Project Name: * I-40 and SR3015 (Airport Blvd) Interchange and additional lane on I-40 WB from SR 3015 to I-540

From: [Riffey, Deanna](#)
To: [Andrew E. Williams](#); [Ridings, Rob](#)
Subject: I-5700 Construction Changes
Date: Friday, September 24, 2021 3:37:00 PM
Attachments: [I-5700 Changes Comparison Sheet \(2021-09-24\).pdf](#)
[I-5700 Permit Drawing Modification \(2021-09-23\).pdf](#)

**AUGUST 17, 2021
REVISED PERMIT DRAWING
SHEET 1 OF 5**

PERMIT DRAWING
MODIFICATION FOR
PERMIT SITE 5C, 6, & 7

AUGUST 17, 2021
REVISED PERMIT DRAWING
SHEET 3 OF 5

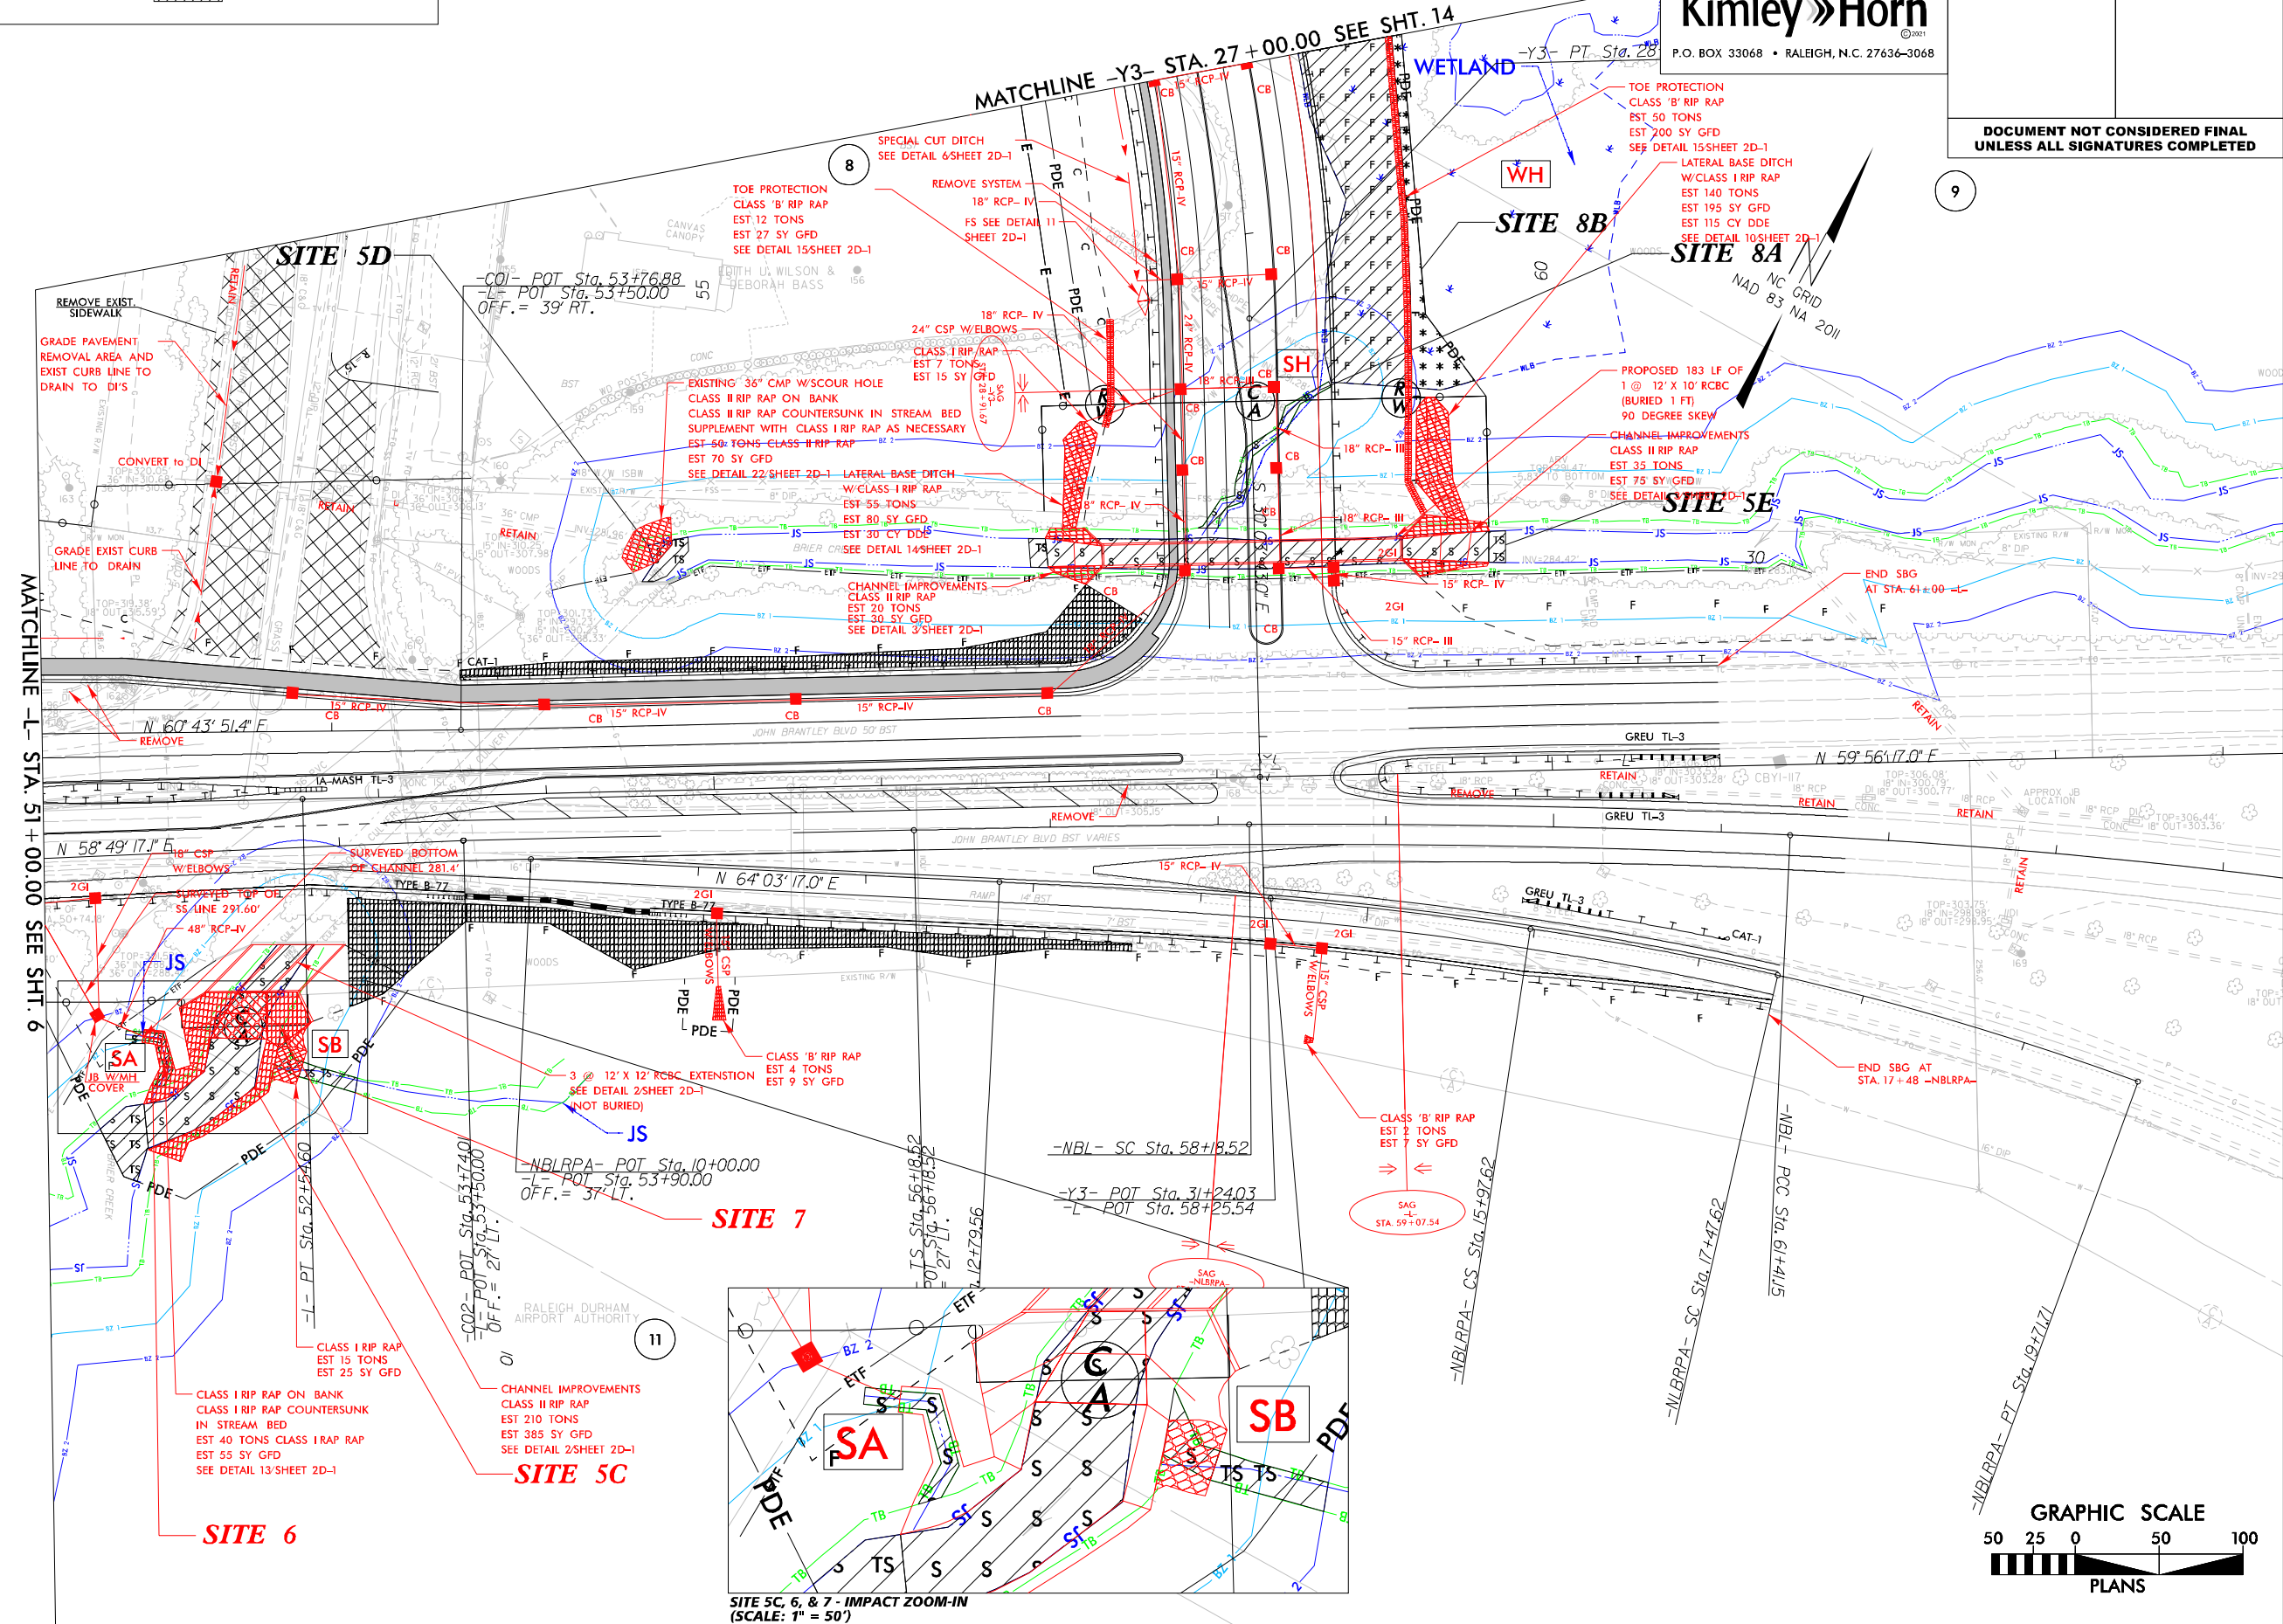
I wanted to check with you both whether this email could suffice in lieu of a formal permit mod package submittal for minor changes for I-5700. Division 5 has notified us on some necessary changes that needs to be made prior to construction at Sites 5C, 6, and 7 (see attached plans). Site 5C is Brier Creek and Sites 6 and 7 are intermittent streams that connect to Brier Creek. Where stream SA (Site 6) comes into Brier Creek (Site 5C) severe erosion has naturally taken place and has changed elevations since plans were developed. Brier Creek will be have a 48" RCP and will provide a bit of water into this eroded area. Site 7 has had erosion issue as well and will need some additional temporary changes. We are having to change the protection in this area of the project where the three streams combine due to the future construction of the pipe system now being at different elevations than was on plans and to account for erosion.

Currently, the rip rap bank stabilization on the west side of the Brier Creek was not extended down to meet this tie in with SA leaving a gap in bank stabilization between the end of previously proposed bank stabilization at Brier Creek and the new proposed rip rap associated with the tie in of SA. We would like to extend the bank stabilization on the west side of Brier Creek to match the east side at Site 5C to prevent erosion of the bank for the entire distance between the culvert outlet and SA. No more permanent stream impacts will be added to what is there now due to the linear stream impacts already on the east side and not adding anymore linear stream impacts. For Site 6 (SA), due to the erosion of the channel along with elevation changes and the amount of water expected to be in this channel, we would like to rip rap the channel at the tie in with Brier Creek. The rip rap will be countersunk in the flow line and will be an additional 42 linear feet (52 linear feet total) of permanent fill impact for SA. We were not planning to propose mitigation due to the additional 42 ft being countersunk rip rap that will not impede the stream function. Site 5C will have temporary impacts reduced from 53 feet to 26 feet and Site 6 will have now have 0 temporary impacts from the proposed changes. No additional buffer impacts for either Site.

As for Site 7 (stream SB), due to limited access to the site to construct downstream channel improvements, a temporary stream crossing was added at Permit Site 7. This temporary stream crossing will be located within the footprint of the originally permitted 24 linear feet of temporary stream impact to SB. However, an additional 10 linear feet of temporary stream impacts to SB is proposed to allow for dewatering of the channel while the temporary stream crossing is constructed.
